**Re: Project Metrolink - Phase IIa Building Damage Assessment for Cadenza Building on Earlsfort Terrace**

**Ref: 24-115-TN001 (Rev.1)**

This technical note presents the results of the Phase 2a assessment of building damage that could occur due to tunnelling-induced ground movements during the construction of the Metrolink Tunnel under the Irish Life Cadenza Building on Earlsfort Terrace in Dublin City Centre.

Figure 3-7 Profile of anti-flotation anchors for rainwater harvesting tank

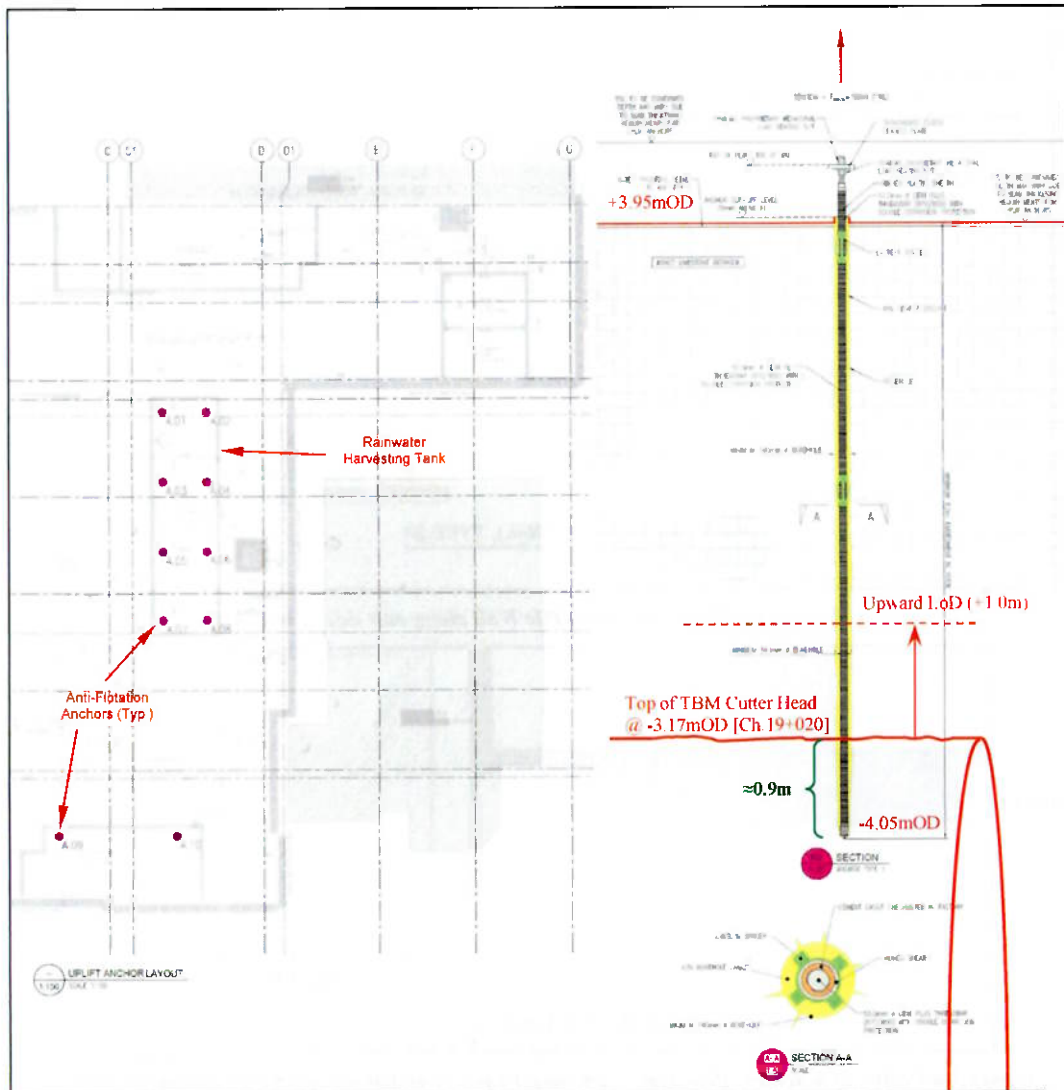
Significantly, as discussed in Section 3.0 and illustrated in Figure 3-7, at the design tunnel alignment the TBM cutter head will hit the bottom 0.9m of the anti-flotation anchors for the rainwater retention tank in the basement and this will increase to 1.9m if the tunnel is raised by 1.0m to the upper limit of the LoD.

The anti-flotation anchors under the rainwater harvesting tank could be avoided by moving the horizontal alignment of the tunnel 15.0m to the west. However, are additional anti-flotation anchors for another tank in the basement at the south end of the building that could be impacted, as shown on Figure 3-7. This would also adversely impact the façade and entrance lobby on the west side of the building, as discussed.

Figure 4-2 Geological Cross-Section [Sheet 26 of 28 from Appendix A20.9 to Chapter 20 of the EIAR]

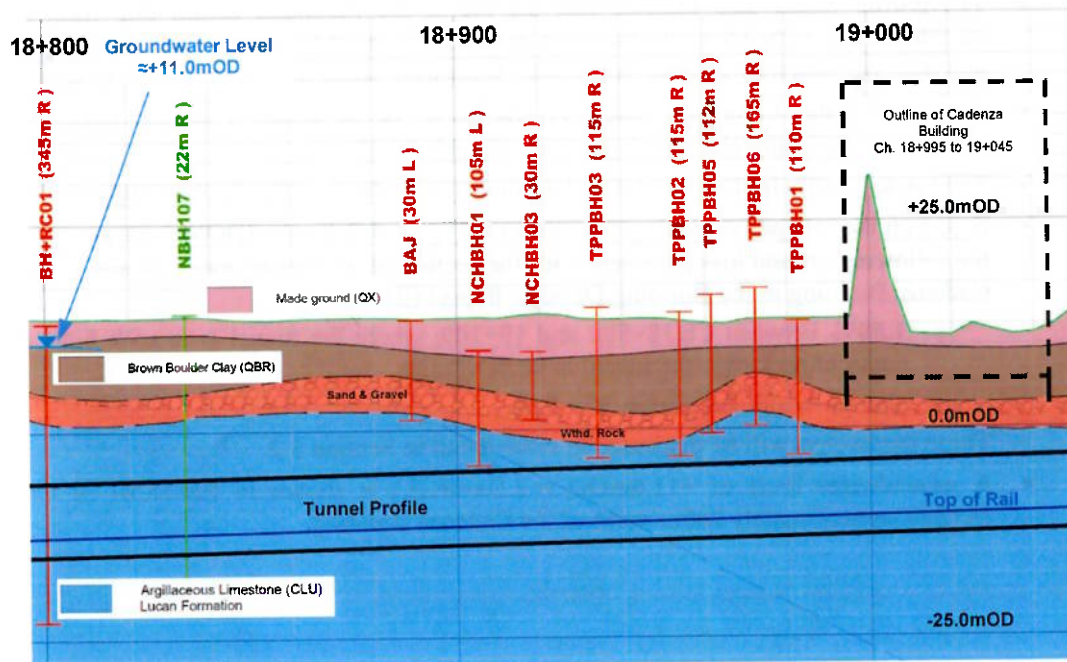
- None of these boreholes are identified on the geological cross section in Figure 4-2.
- None of the logs for the investigation points shown on the location plans or geological sections were included in the EIAR so it is not possible to verify the ground conditions interpreted by Jacobs/IDOM.

- The interpreted geological section in Figure 4-2 would indicate that the subgrade for the basement floor slab at +6.00mOD is in the glacial till deposits of Boulder Clay.

- The profile would also indicate that the toe of the perimeter secant pile wall, at +2.50mOD, is embedded into the Sand & Gravel layer at the base of the Glacial Till and does not penetrate into the underlying Weathered Rock or Limestone bedrock.

- The top of the Limestone Rock is shown to be at about 0.0mOD, which is approximately 6.0m below the basement subgrade level.
- The tunnel profile is shown to be in the Limestone bedrock under the building.

The site investigation carried out on the site of the Cadenza Building in 2018 indicates that the top of rock is at a higher level than shown on the geological cross section produced by Jacobs/IDOM for the EIAR (Figure 4-2) i.e.:

- 2018 Ground Investigations: **+6.3mOD to +7.6mOD**
- Jacobs/IDOM Cross Section (Figure 4-2): **+0.0mOD**
